CASE OFFICER'S REPORT

Application Reference: PL/2023/05795
Application Address: Knapp Farmhouse, 1 High Lane, Broad Chalke

This application seeks permission for demolition of timber garage, workshop, shed and partial demolition, repair and rebuilding or boundary walls and erection of new garage, workshop and gymnasium with associated works.

EXISTING WEST ELEVATION

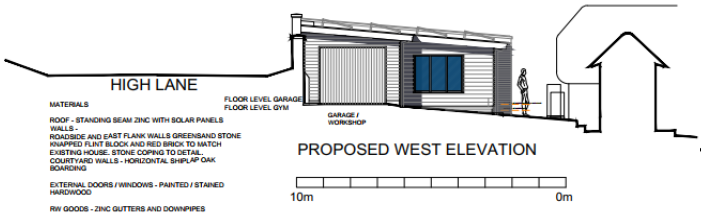
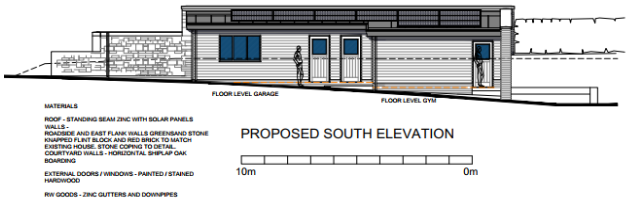
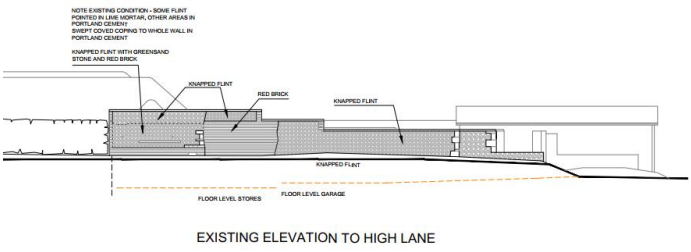
The existing is a modest single storey garage with a shallow pitched roof, which is proposed to be replaced with a single storey garage, with workshop and gym to the rear. The garage will extend to the east, in a similar style to the existing, with a monopitch roof set below the main dwelling, in wrap around, L shaped style. The external materials are to be greensand squared tumbled stone with red brick strong courses to the roadside and east walls, and horizontal shiplap oak boarding to the courtyard facing walls, with a standing seam zinc roof with solar panels. The external materials are considered suitable in preserving the character and appearance of the listed building. The Conservation consultee, in their response, stated that the outbuildings are of no heritage interest, and they do not consider the buildings to be of significance, with no objection to their demolition. In terms of the proposed replacement building, no objection was raised to the proposed footprint or design, noting the overall height is maintained at a low level so would not, or only partially, be visible above the top of the newly rebuilt wall. The proposed solar panels to the roof of the outbuilding are not deemed of negative impact on the setting of the listed building, or wider protected landscape, with the Conservation consultee stating that they have no objection to the roof mounted solar panels subject to them not being visible from the road. As the garage roof is to be of monopitch style, slopping to the south, the solar panels would not be visible from the highway.

EXISTING ELEVATION TO HIGH LANE

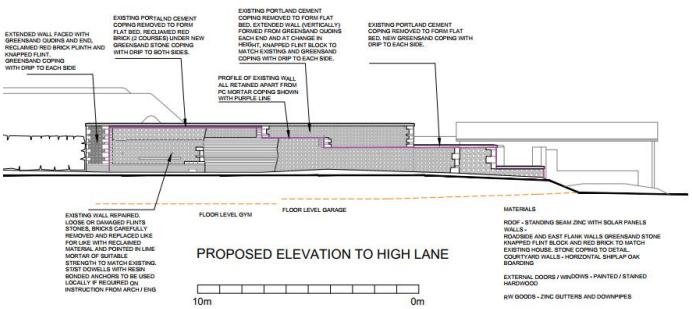
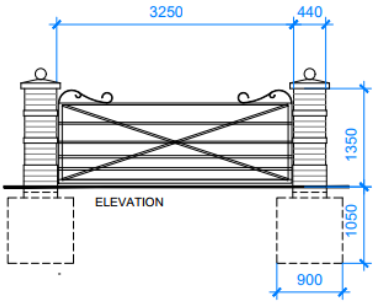
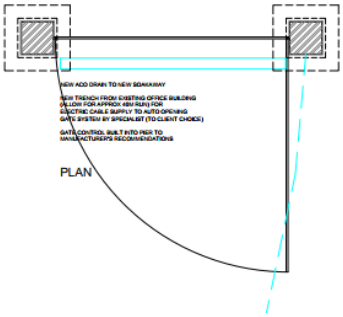
The proposal also sought permission for the demolition and rebuilding of the roadside wall, adjacent to High Lane, however this was considered detrimental and was objected to by the

Conservation consultee. Revised plans were submitted, to instead propose retention of the existing wall, and extending this at the eastern end, partially raising the height of the wall to remove the central step down.

The revised proposal for the boundary wall to the highway is welcomed, and addresses the concerns raised by the Conservation consultee, retaining its idiosyncratic character. Noting the age of the wall, concern was raised regarding how the proposed works and building behind would impact on the wall given it is likely that the wall does not have deep footings. It is recommended that a condition be implemented requiring the wall is stabilised during the course of works and that any underpinning is done in sections and as advised by a structural engineer.

4.The boundary wall is to be stabilised, by means such as a temporary buttress, during the course of works and any underpinning is done in sections and as advised by a structural engineer.
REASON: In the interests of preserving the character and appearance of the listed building and its setting.

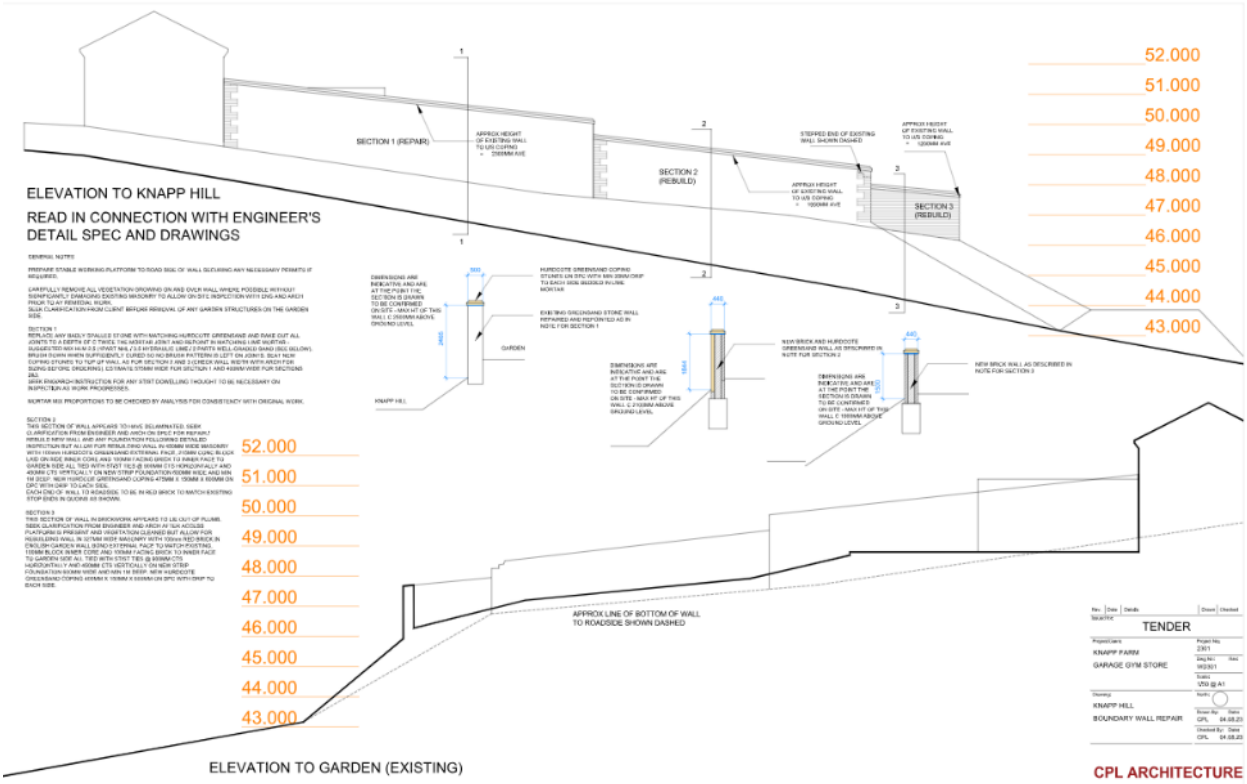
The proposed new gate is to be a galvanized etched and painted steel with electric auto opening, sited to the to the north eastern corner of the site, adjacent to the proposed extended portion of the wall. 2 new brick piers are proposed to form support to the proposed gate, replacing the existing timber gate and gateposts. This is not considered of harm to the setting of the listed building, or wider setting, given the sites location in the Conservation Area and AONB.
